SLIDING SEAT STOPPER INSTALLATION 9700 (B13R)

DESCRIPTION

This bulletin describes the installation of stoppers on the seat rails to limit the motion of the sliding seats when installing a wheel chair.

FIGURE 1

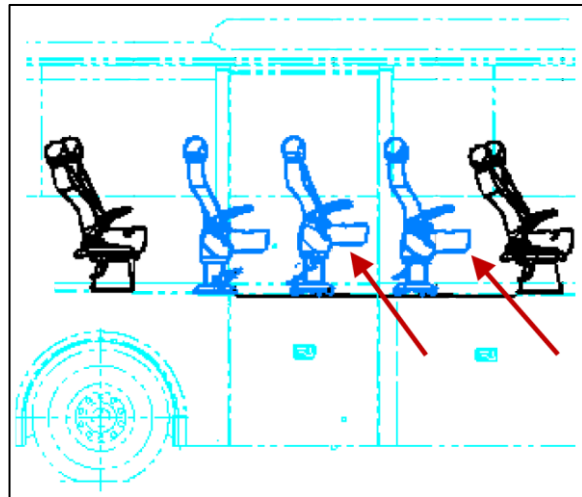
1. Locate the sliding seats on both sides of the vehicle (Figure 1).

FIGURE 2

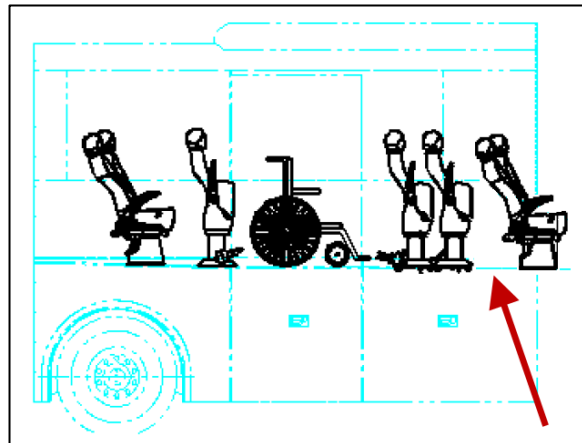
2. Locate the front side end of the sliding seat rails (4) on both sides of the vehicle (Figure 2).

FIGURE 4

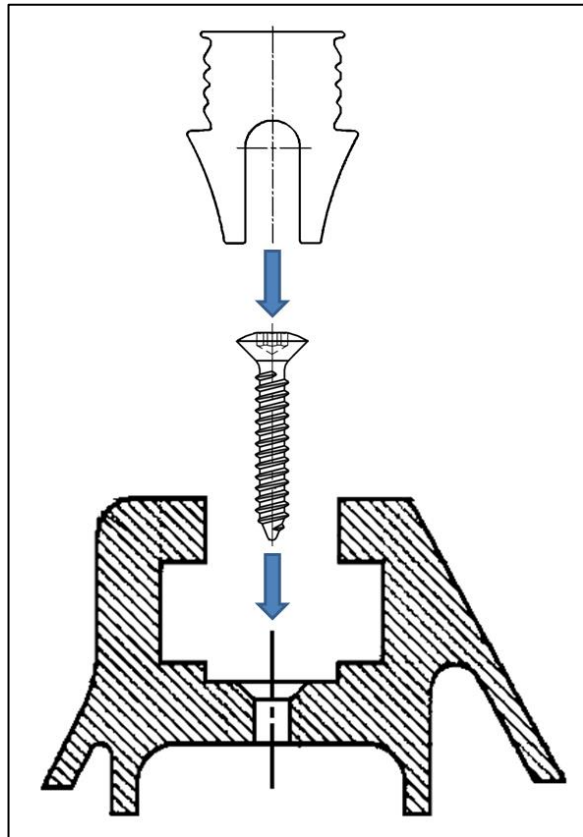
6. Install parts as shown in figure (Figure 4).
7. Repeat previous steps with the other three sliding seat rails.
8. Bulletin is complete.
